Comment on ACCC type conductors and ice load, SEC 2024-02 and DE-24-087

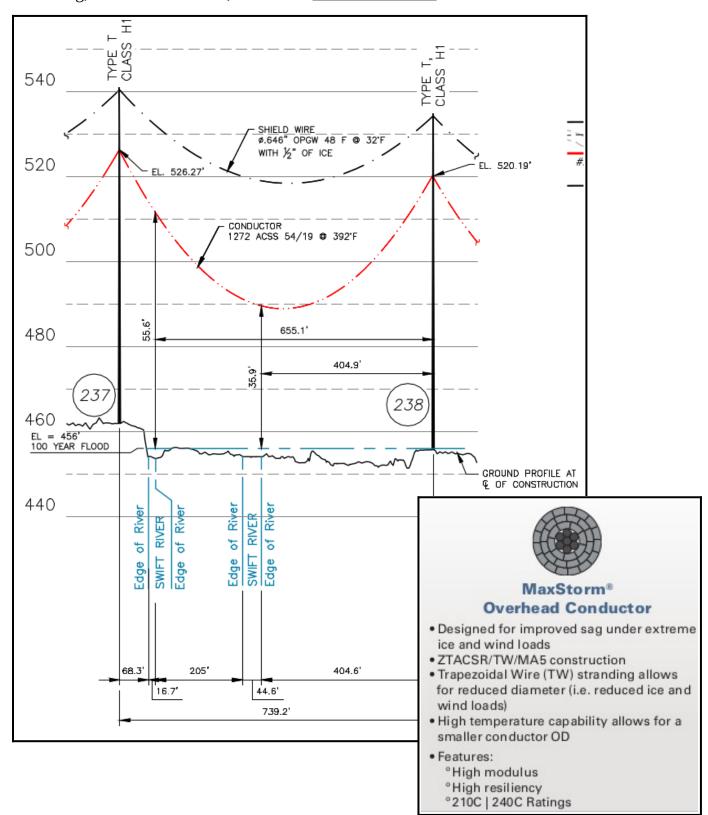
Eversource again fails to mention that the NESC ice loading standard applies only to structures taller than 60', and is silent on the reduced line losses of ACCC type conductors.

The <u>diagram</u> above indicates Eversource's statement appears to be false.

1026 ACCC is shown as having 14' sag at 800' with NSC heavy ice load, comparable to the existing 795 ASCR Pheasant conductor

Where are Eversource profiles with ACCC type conductor, the typical (shorter than 800') spans on the X-178, structure heights below 60' (not subject to NESC heavy loading) and no ice?

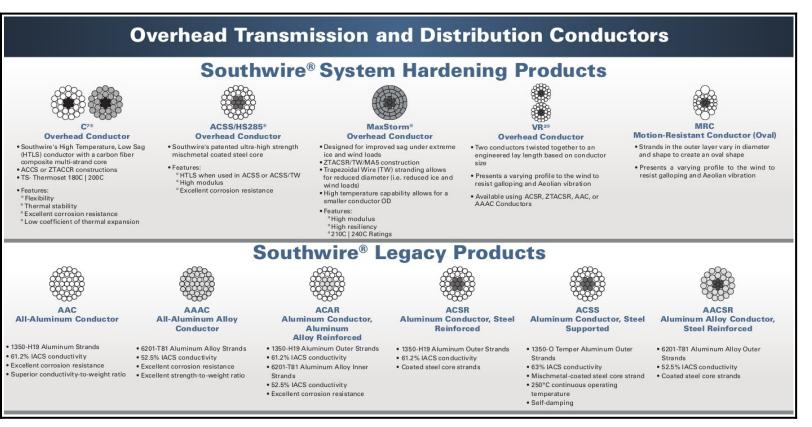
Below: Eversource's <u>proposed</u> 2,200 amp 1272 ACSS at 739' has 35' sag at 392 F, its condition of maximum sag, 20' more than the 1,026 ACCC <u>with ½" radial ice</u>.

Newer ACCC type conductors designed for ice loads may have even less sag. For example (above right) MaxStorm Overhead Conductor; "Trapezoidal Wire (TW) stranding allows for reduced diameter (i.e. reduced ice and wind loads.)"

Note that Southwire lists ACSS in its "Legacy" category, along with ASCR.

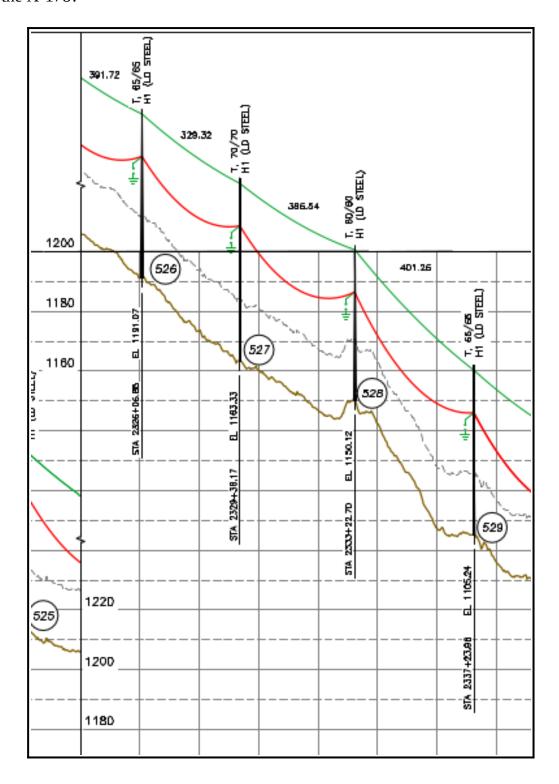
Destruction proceeds on the U-199, a youthful 53 with another twenty years of service left, by which point who knows what progress may have been made in efficiency, conservation and conductors.

Loggers can fell and limb large trees with a tracked feller-buncher but Eversource claims it cannot set light-duty poles without a road and 100' x 100' construction pads. The plans for this area show wetland and uplands matting placed where the road and part of the lower construction pad are, so why has Eversource been allowed to excavate wetlands when it is required to place matting on the wetlands to protect them? Why has it built what appear to be two construction "pads" into the steep slope above structure 62 rather than laid wetlands/upland matting around it?

Should we assume Eversource is exceeding Code clearances and increasing structure heights here far beyond what is required to carry its high sag conductor, as it plans to do on the 49 miles of the X-178?
